SERVICE BULLETIN

M-1190

2006 TOURING FORK LOCK PRODUCT PROGRAM 0900

Figure 1. Touring Model Ignition Switch/Fork Lock

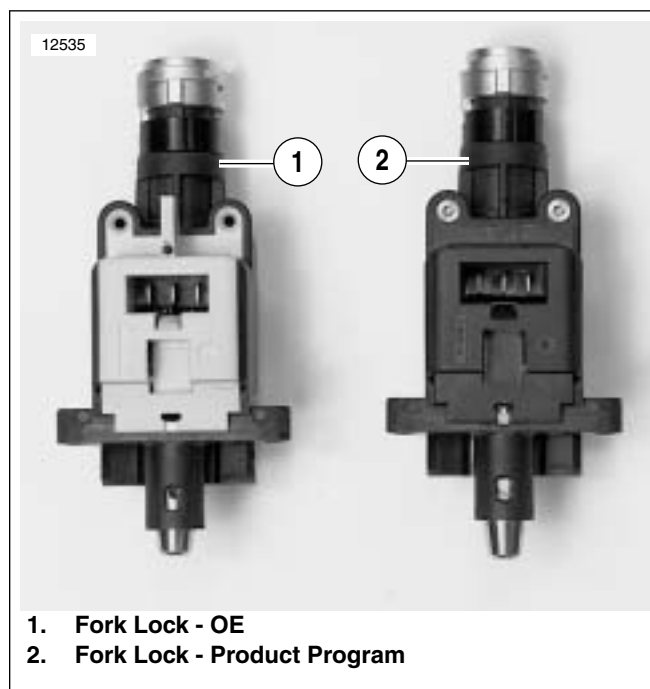
Harley-Davidson Motor Company, Inc. has learned that the fork lock on 2006 Touring Models can be broken if the rider attempts to turn the handlebars while the forks are locked. If the spring or cam connecting link is broken, the locking barrel will not retract from the boss on the frame bracket.

Unlocking the switch knob with the ignition key will not unlock the forks. Repairing the lock will require removal and replacement of the ignition/light key switch and fork lock.

See Figure 1. Replace existing OE fork lock (1) with the replacement (2) from the Product Program. Refer to IGNITION/LIGHT KEY SWITCH AND FORK LOCK service procedures in the 2006 Touring Models Service Manual.

Figure 2. Switch Knob and Key Lock Positions

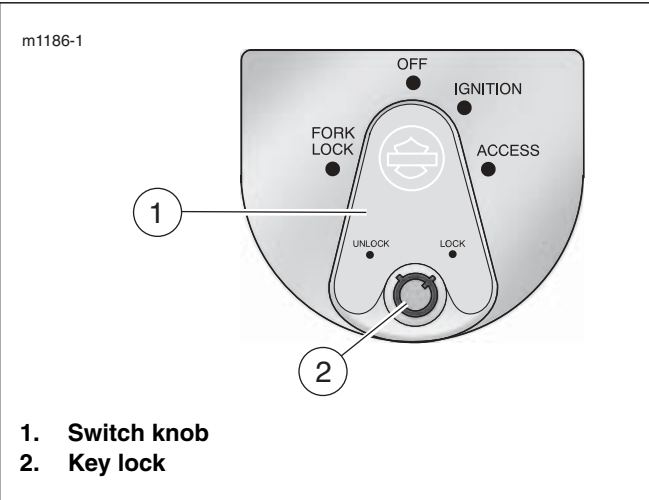
See **Operation** and Figure 2. After installation of the replacement switch, explain the new operation procedures of the fork lock to the customer.

- 1. See Figure 2. Turn the front forks to full left lock and insert ignition key into key lock (2).
- 2. Turn switch knob (1) to FORK LOCK and push knob down.
- 3. While holding knob down, turn key to LOCK and remove key.

- 1. Insert ignition key into key lock.
- 2. Push in and turn to UNLOCK. The switch knob will pop up.
- 3. Turn switch knob to OFF.
